M12 Motorway

Amendment Report

October 2020

- The amended project
- The amended project (Elizabeth Drive connection)
- Shared user path
- Bridges
- Motorway
- Existing roads
- Waterways

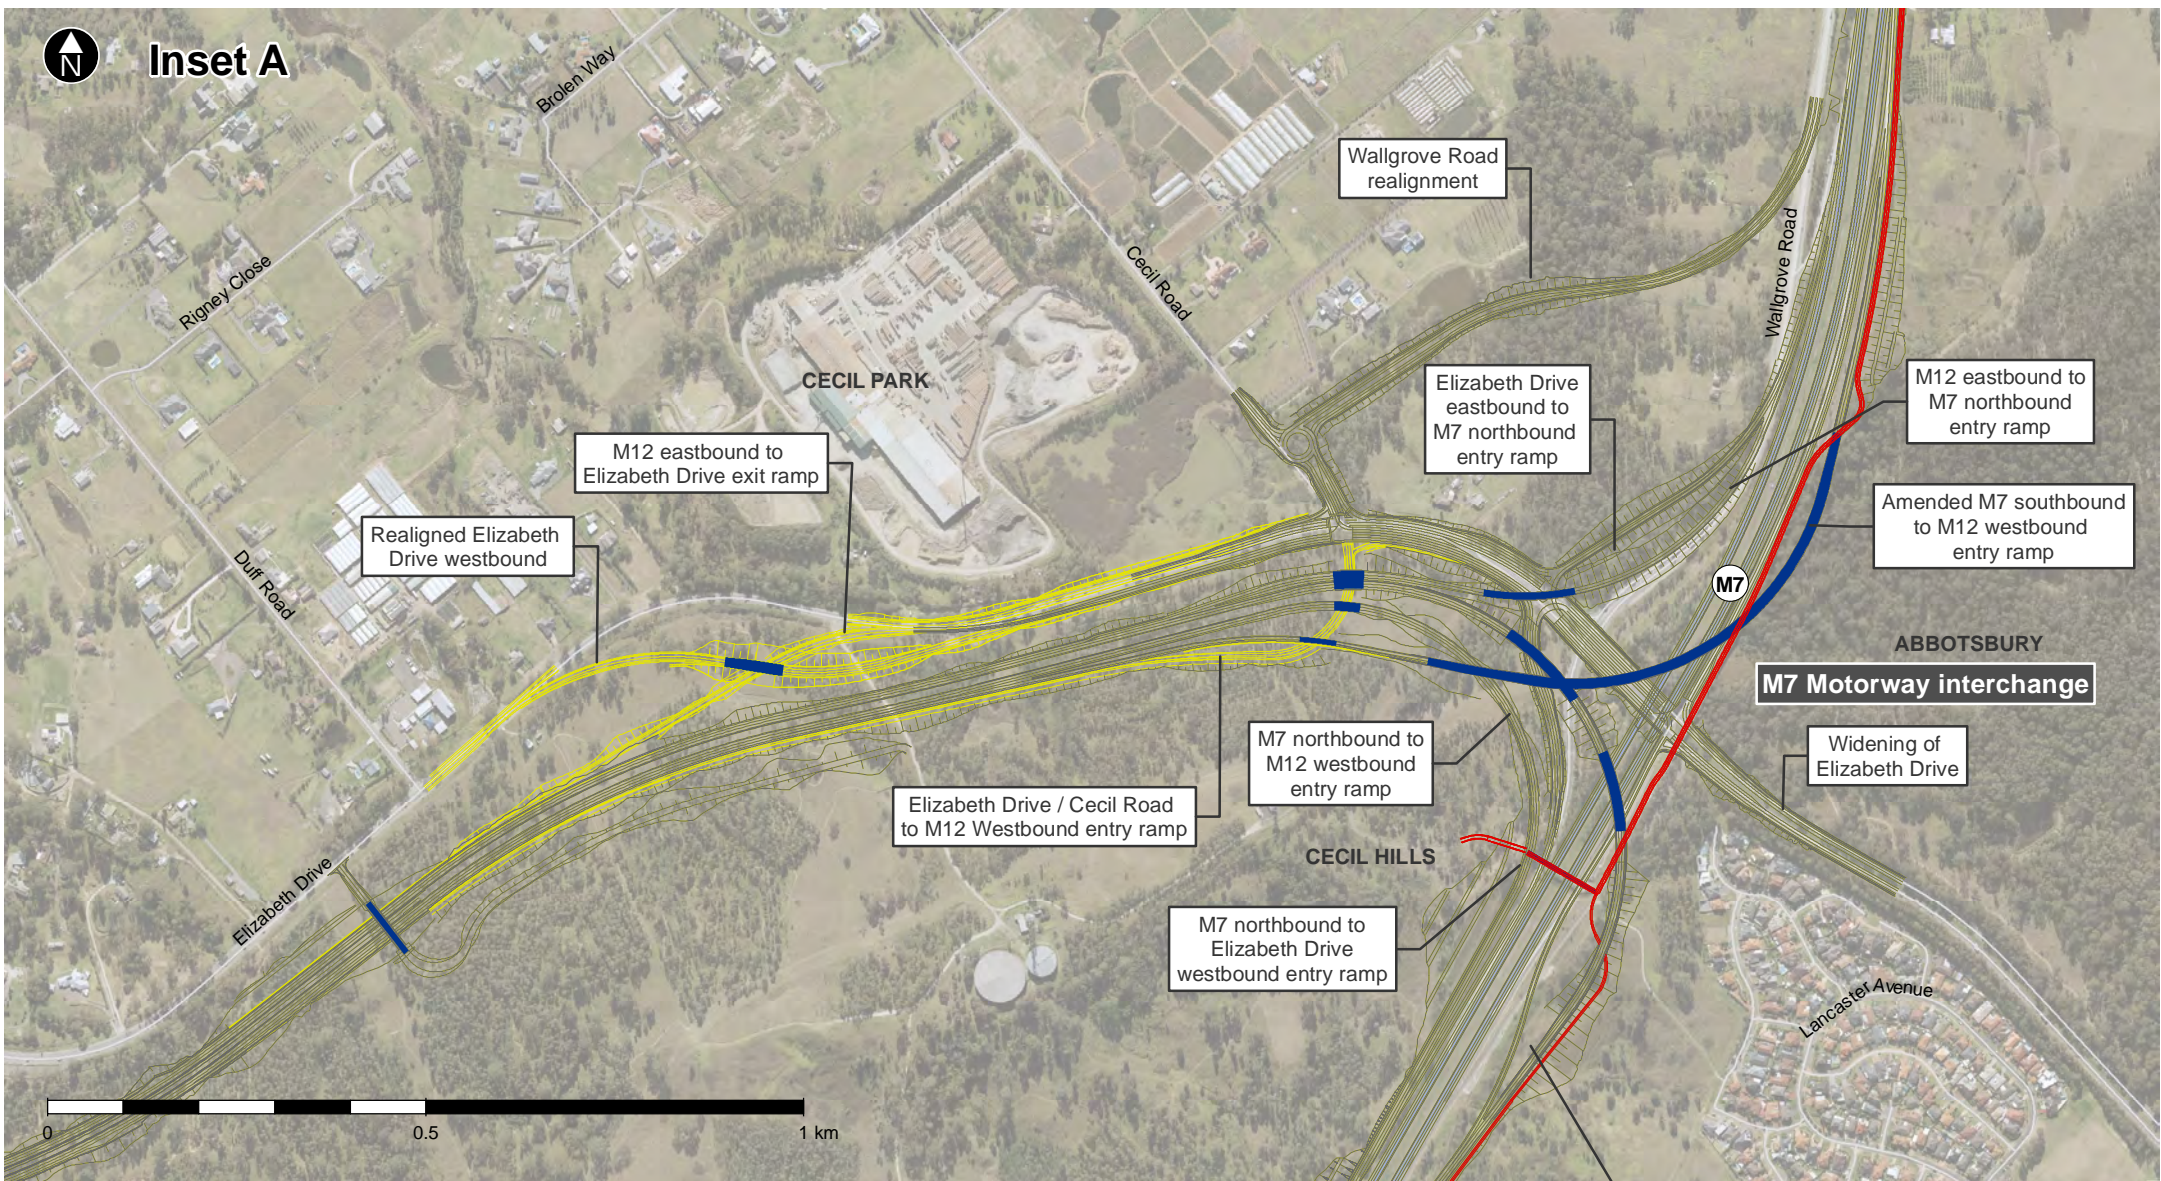
The key features of the amended project are listed below and shown in **Figure A-1**.

- A new dual-carriageway motorway between the M7 Motorway and The Northern Road with two lanes in each direction with a central median allowing future expansion to six lanes

- Motorway access via three interchanges/intersections:
 - A motorway-to-motorway interchange at the M7 Motorway and associated works (extending about four kilometres within the existing M7 Motorway corridor) with the following options:

- Option 1 – without connection between the M12 Motorway and Elizabeth Drive
 - Option 2 – with connection between the M12 Motorway and Elizabeth Drive (Note: The decision on which option would be built is dependent on funding being available to include the Elizabeth Drive connection).

- A grade-separated interchange referred to as the Western Sydney International Airport interchange, including a dual-carriageway four-lane airport access road (two lanes in each direction for about 1.5 kilometres) connecting with the Western Sydney International Airport Main Access Road

- Modifications to the local road network, as required, to facilitate connections across and around the M12 Motorway including:
 - Realignment of Elizabeth Drive at the Western Sydney International Airport, with Elizabeth Drive overpassing the airport access road and rail infrastructure

- Two new signalised intersections from Elizabeth Drive into the Western Sydney International Airport, with provisions for future connection to potential developments to the north

- Widening of Elizabeth Drive under the M7 Motorway and approaches
 - Realignment of Clifton Avenue over the M12 Motorway, with associated adjustments to nearby property access

- Relocation of Salisbury Avenue cul-de-sac, on the southern side of the M12 Motorway
 - Realignment of Wallgrove Road to connect to Cecil Road, including a connection between Elizabeth Drive and Wallgrove Road via Cecil Road with a signalised intersection with Elizabeth Drive
